**RE: 53 Danforth Street – Portland, Maine**

Past Use: Auto Repair Business	Proposed Use: Multi-Family - Build new Forty-three (43) units of workforce housing	Permit Fee: \$38,375.00	Cost of Work: \$3,828,000.00	CEO District: 1
Proposed Project Description: Build new Forty-three (43) units of workforce housing		FIRE DEPT: <input checked="" type="checkbox"/> Approved <input type="checkbox"/> Denied <i>See Conditions</i>	INSPECTION: Use Group: R-2 S2 Type: SA 1B IBC-2003

I have completed the review of the above project and have the following questions or require the following additional information:

Mike Nugent  
Consulting Plans Examiner  
City of Portland

**DRAWING SOLAR TANK LOCATION ADJUSTEMENT FOR ELECTRICAL PANELS**

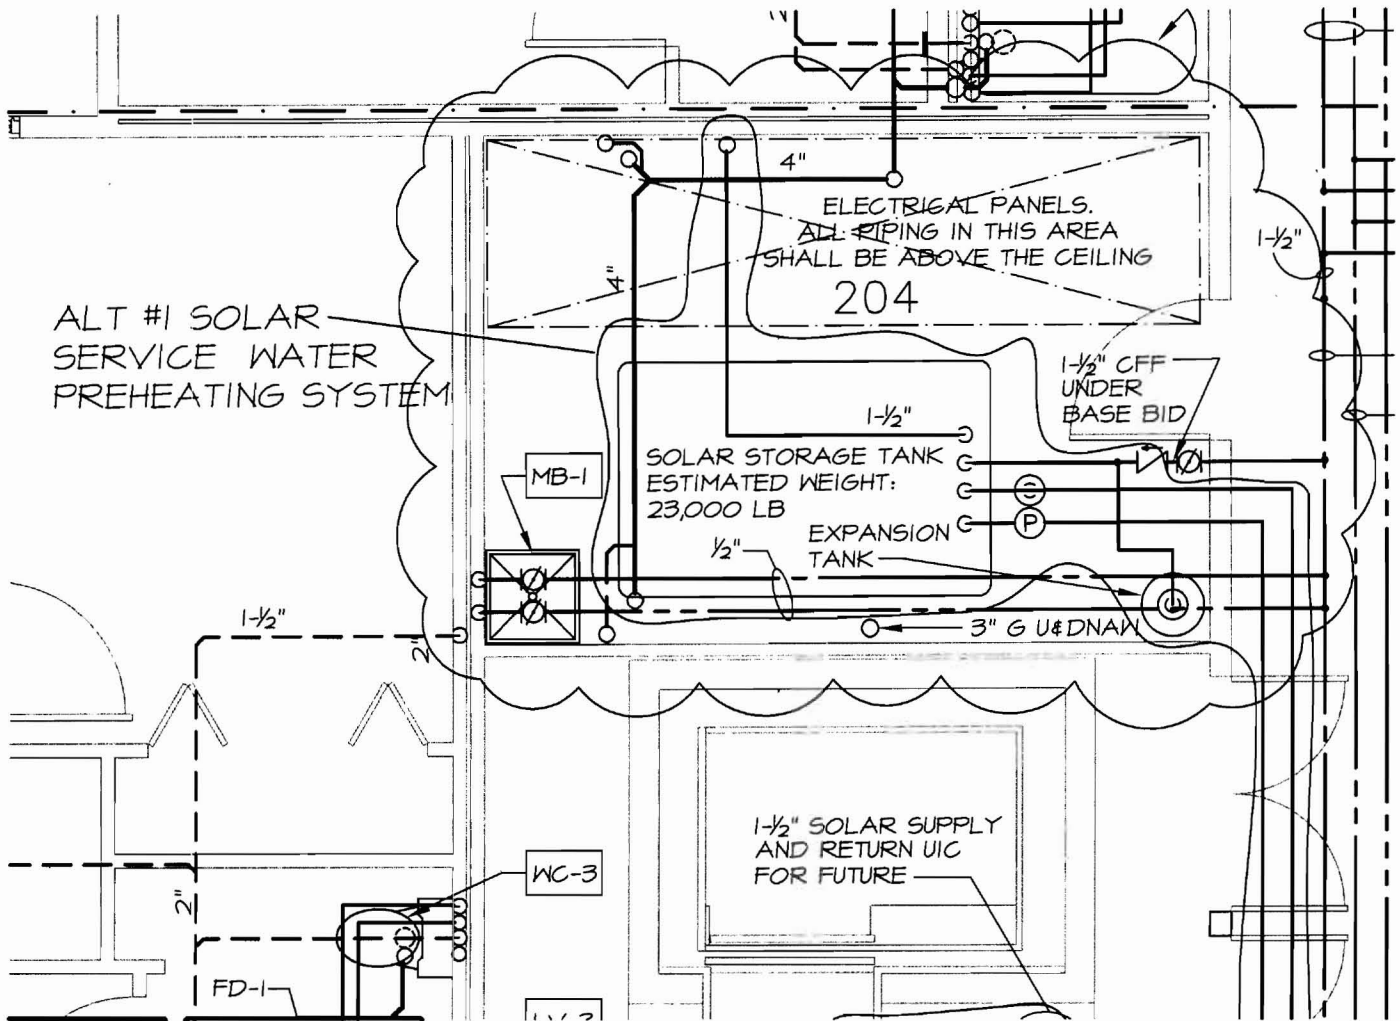
1. See drawing SK01 below for changes to the door at elevator lobbies floors 2 through 5 which will provide a one hour separation between the lobby and the corridor.
2. Due to an adjustment in the Seismic Design Classification the attached specification sections must be modified to incorporate changes to the installation of the acoustic tile suspended ceilings and the piping hangers. See below.
3. See drawing SKPL-1 below for relocation of the water storage tank and associated equipment in the Solar/Janitor room on the second floor north of the elevator. This will allow for the installation of electrical equipment as designed.
